TRIUMPH DISTRIBUTORS

TO: ALL DEALERS

SUPPORT STRAP DETAILS

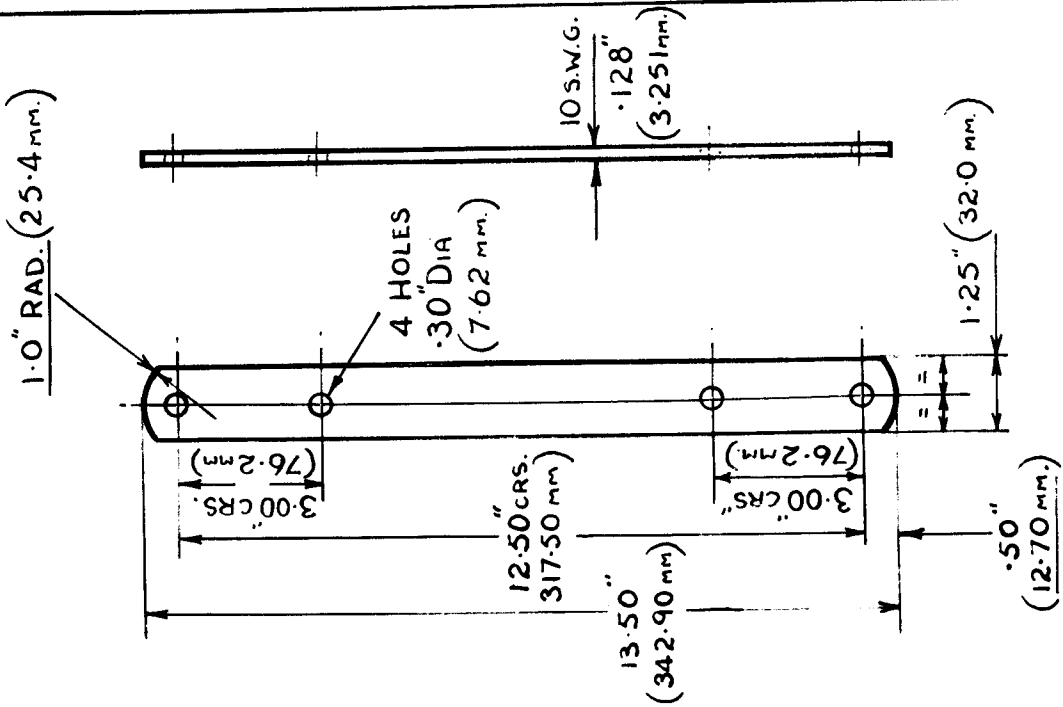
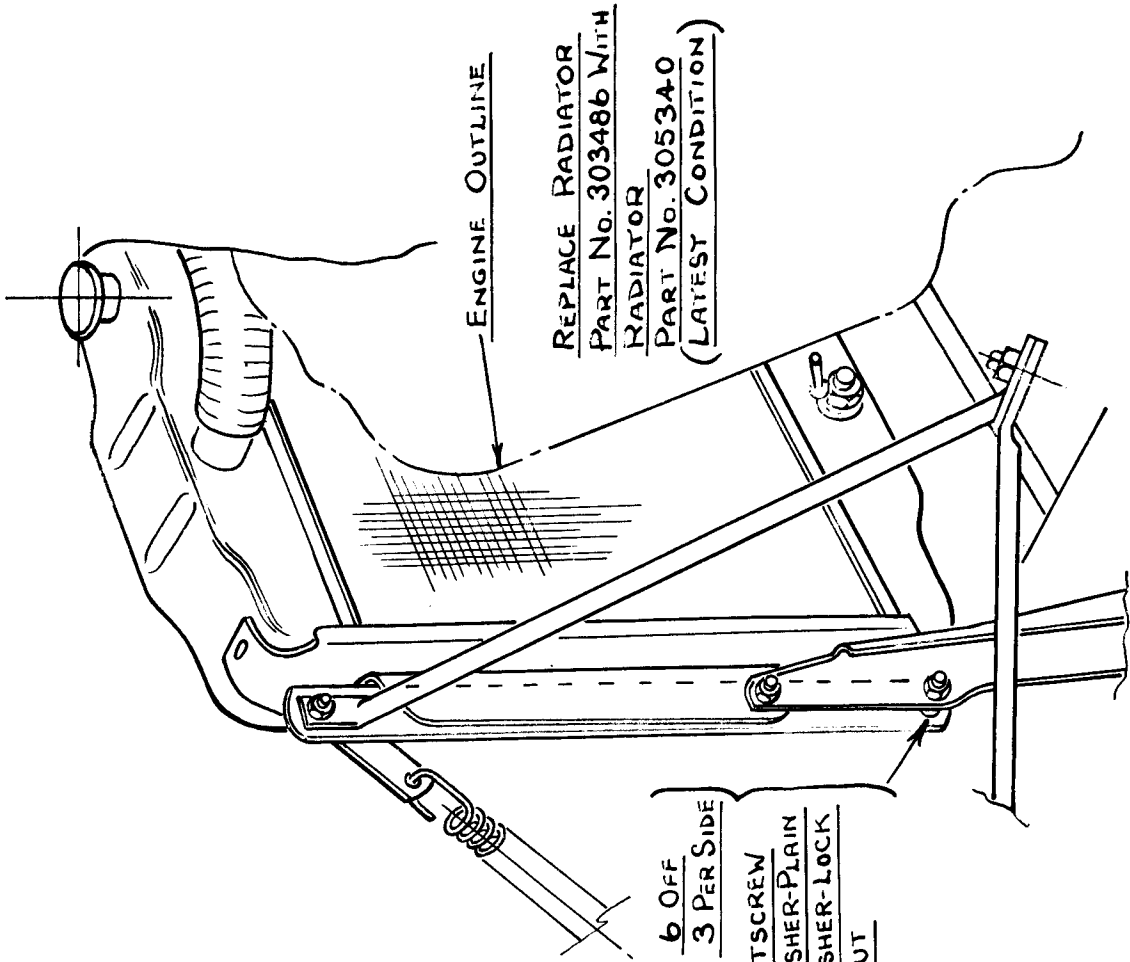
Since the introduction of the Herald range of models, modifications to the radiator mounting have necessitated three changes of part number.

1. Attach radiator, as received from stock, to valance sides by 4 fixing bolts (2 on either side, using the middle holes).
2. Attach hood stay rod bracket to top hole of R.H.S. valance.
3. Fix latest type counter balance spring brackets Part Number 130030 to second hole from top on each side of the radiator, in place of original brackets which are unsuitable.
4. Refit horns, as originally fixed.
